Flight Procedures Cover Page	Task Action: FLIGHT CHECK	Task Type: SID	Estimated Chart Date: 12/31/2020	APWS Task ID: 815D2E907AA64A9F81D79E534183C86F	APWS Project ID: A4862357228848E09DD2F35FF6382908
Procedure: SID SCRAM (RNAV) SIX WASHINGTON DC KDCA		Enroute: YES	Specialist: Lafferty, James		Agreement Number:
Airport ID: KDCA	Airport Name: RONALD REAGAN WASHINGTON NATIONAL	Airport City: WASHINGTON			State: DC
Facility ID:	Facility Type:	Flight Inspection Remark Type: Hold FC Slot			
<p>Procedure Comments: ACTIVE DATA USED FOR KDCA DEPARTURE DEVELOPMENT. ATC REQUESTED CHANGES. APPROVAL LETTER FOR CLIMB GRADIENT. WAIVER FOR LENGTH OF SEGMENT. CONTACT DAVE TEFFETELLER AT 202-267-5177.</p> <p>05/19/20: THIS IS AN UPDATED COPY OF THE FORM DEVELOPED ON 03/19/20. 1. ADDED NOTE: TURBO-JETS ONLY.</p> <p>10/22/20: THIS IS AN UPDATED COPY OF THE FORM DEVELOPED ON 03/19/20. 1. CHANGED RWY01 VI LEG DIST FROM 1.79 TO .61</p>

PROCEDURE: SID SCRAM (RNAV) SIX WASHINGTON DC KDCA		AIRPORT NAME: RONALD REAGAN WASHINGTON		AIRPORT ID: KDCA	SPECIAL CONTROL NO: YG-09-114-20
FAC ID: SCRAM6		CITY: WASHINGTON		ST: DC	ORIG CHART DATE: 12/31/2020
DFL TYPE: PROC/D	THIRD PARTY: <input type="checkbox"/> YES	EST

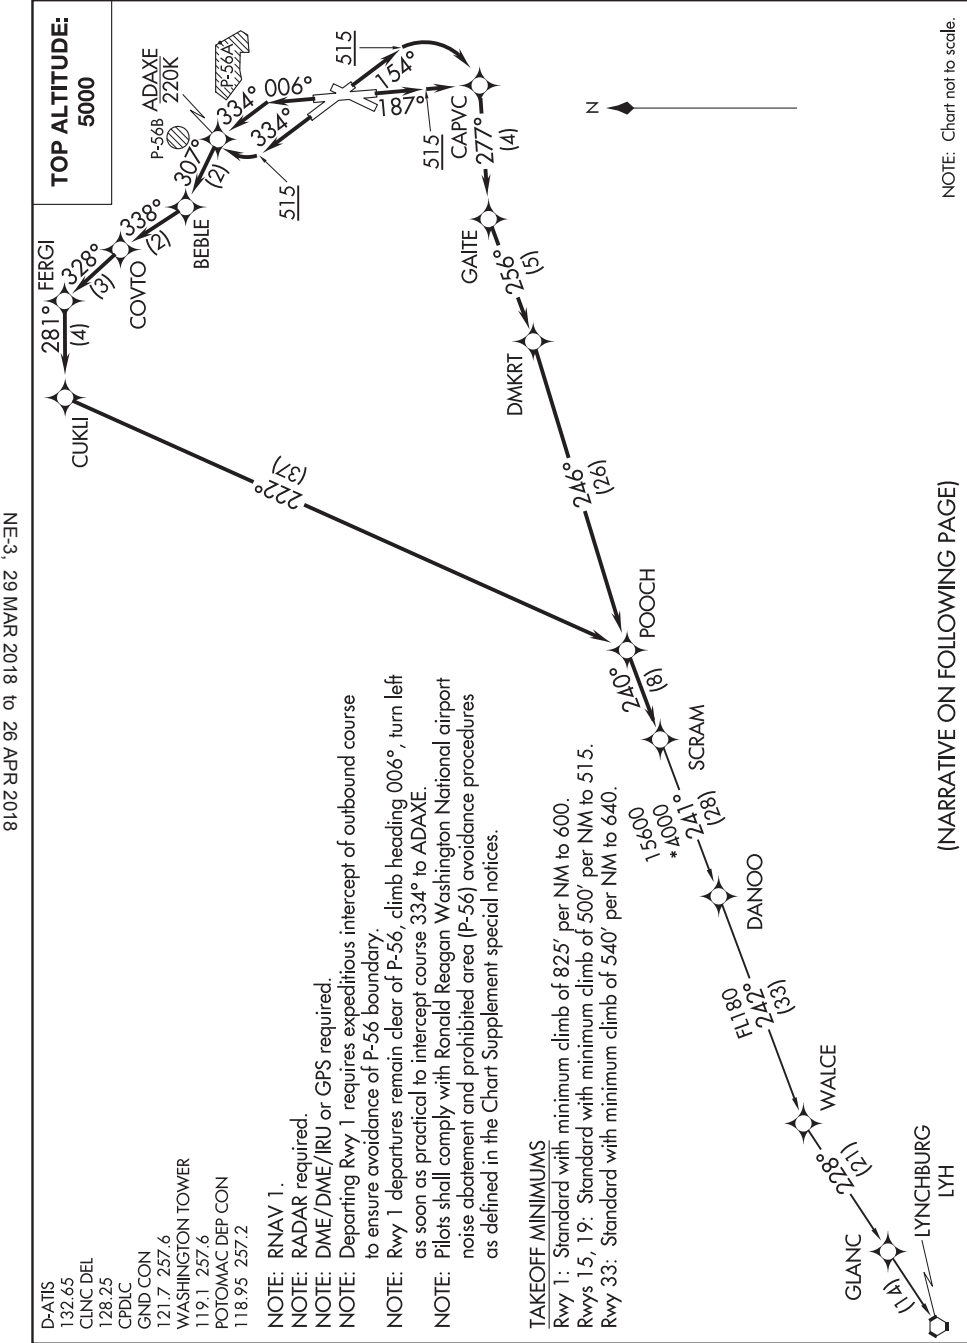
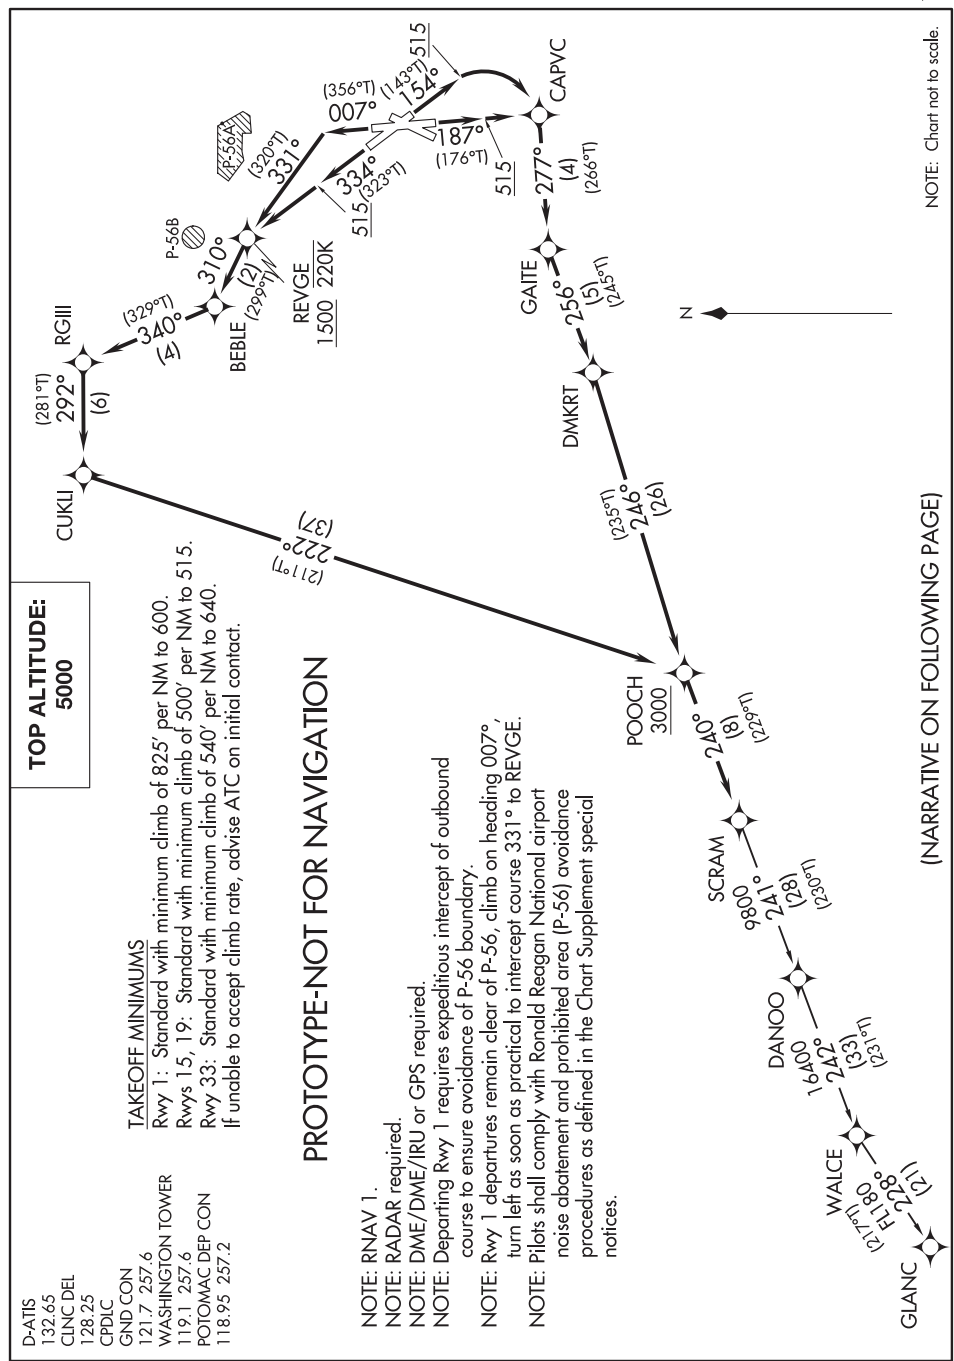
TAKEOFF RUNWAY 1: Climb heading 006° to intercept course 334° to ADAXE, then on depicted route to SCRAM, thence

TAKEOFF RUNWAY 33: Climb heading 334° to 515, then right turn direct ADAXE, then on depicted route to SCRAM, thence

TAKEOFF RUNWAY 1: Climb on heading 007° to intercept course 331° to REVGE, cross REVGE at or above 1500 and at or below 220K, then on track 310° to BEBLE, then on track 340° to RGIII, then on track 292° to CUKU, then on track 222° to POOCH, cross POOCH at or above 3000, thence

TAKEOFF RUNWAY 33: Climb on heading 334° to 515, then direct REVGE, cross REVGE at or above 1500 and at or below 220K, then on track 310° to BEBLE, then on track 340° to RGIII, then on track 292° to CUKU, then on track 222° to POOCH, cross POOCH at or above 3000, thence

AIRPORT ID	KDCA
AIRPORT NAME	RONALD REGAN WASHINGTON NATIONAL
CITY	WASHINGTON D.C.
STATE	
PROCEDURE ID	SCRAM SIX
AMENDMENT #	SIX
CHART DATE	7/16/20
SCALE	1:100,000
SEGMENT	ICA RWY 1

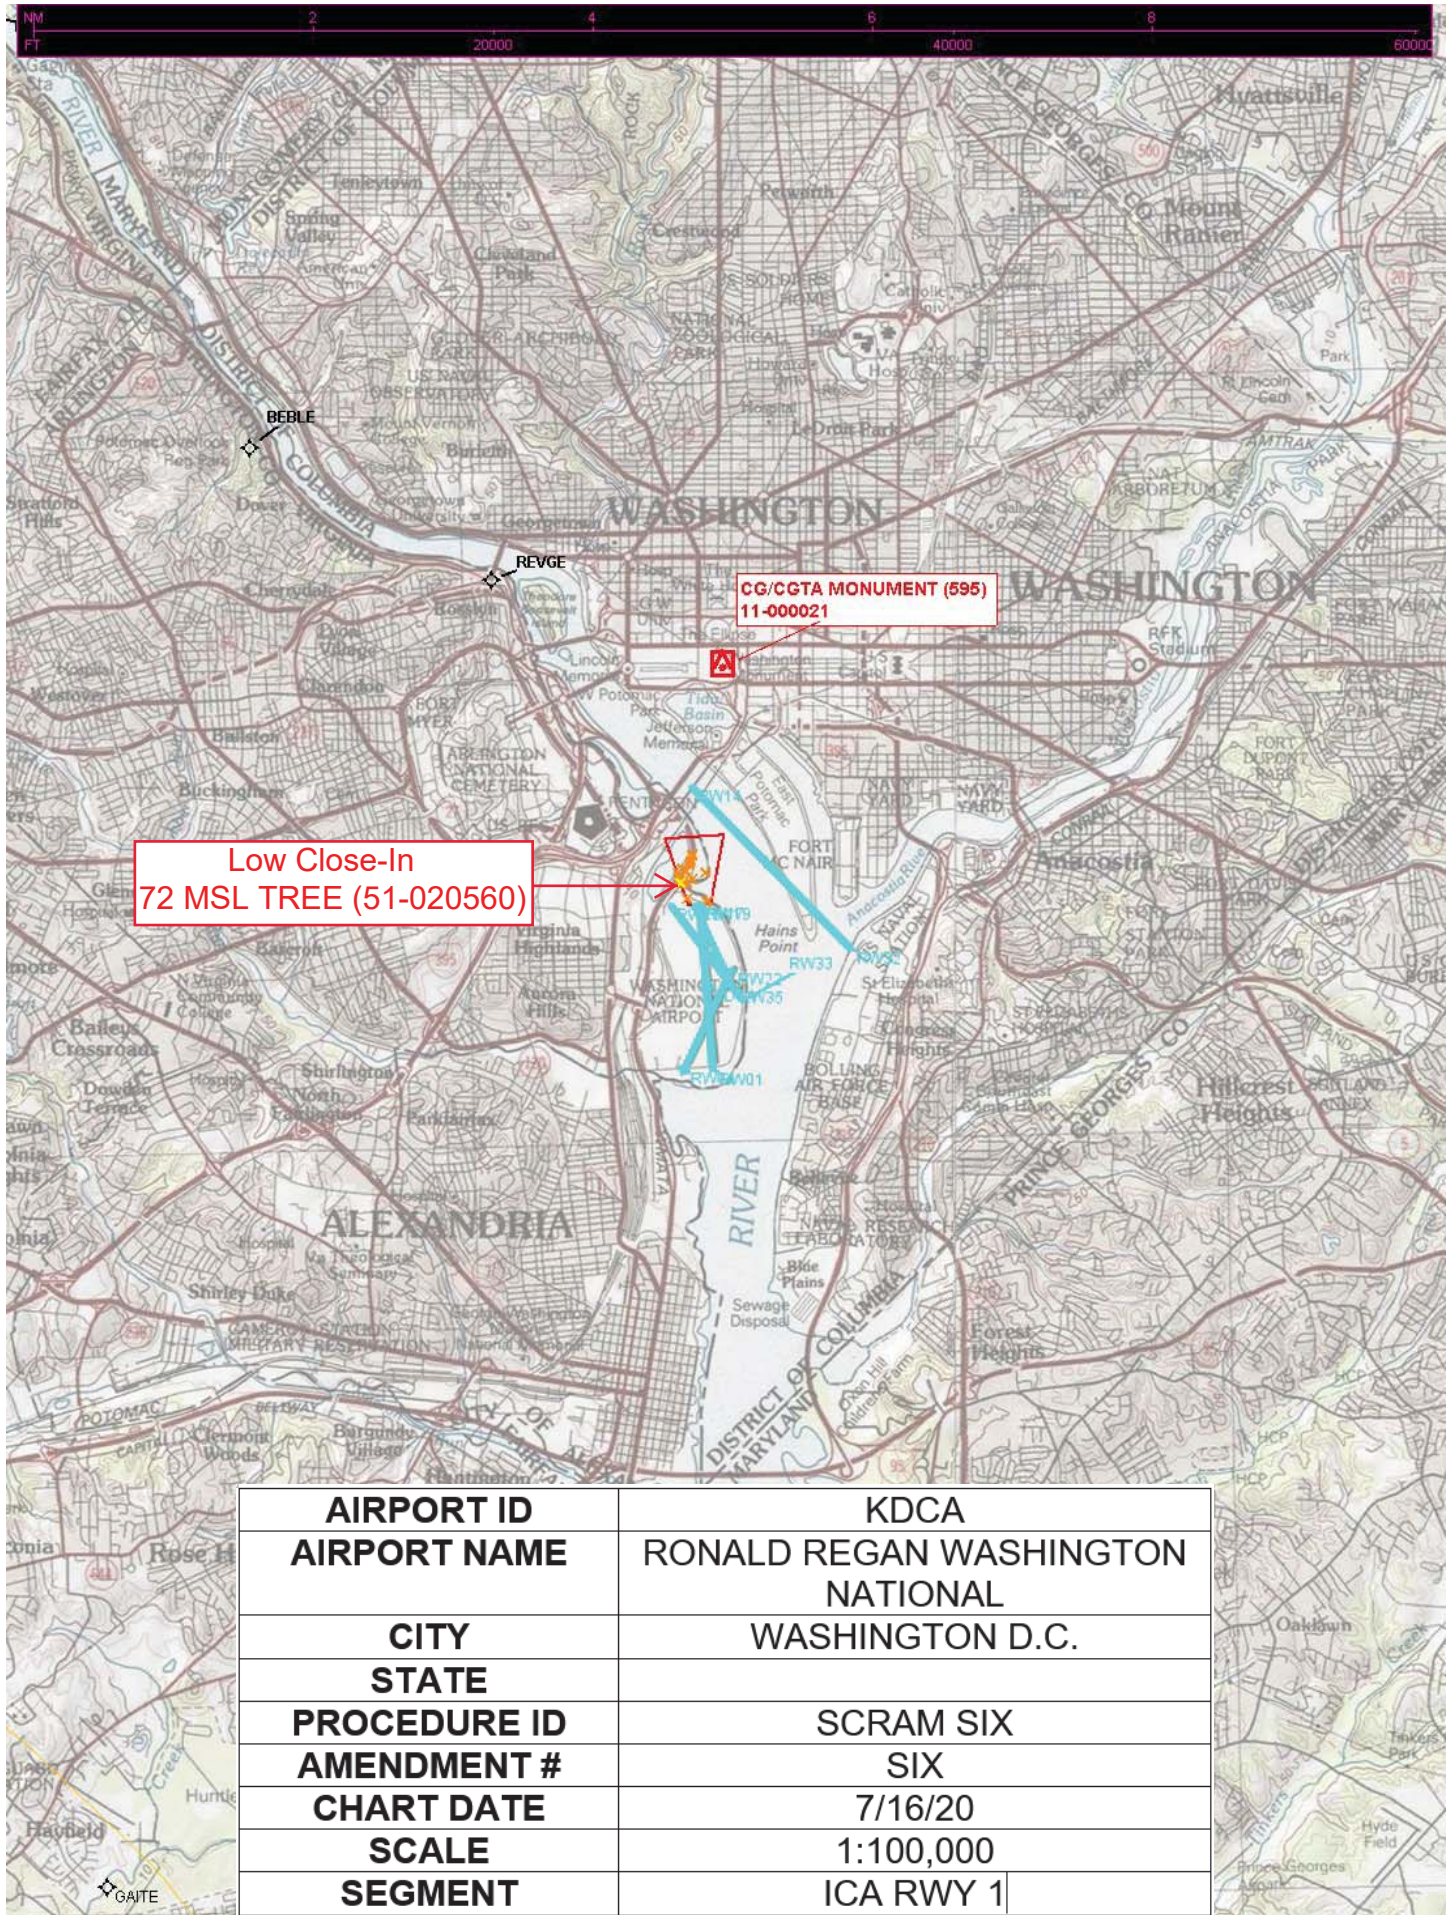
RWY 1

Low Close-In
72 MSL TREE (51-020560)

CG/CGTA MONUMENT (595)
11-000021
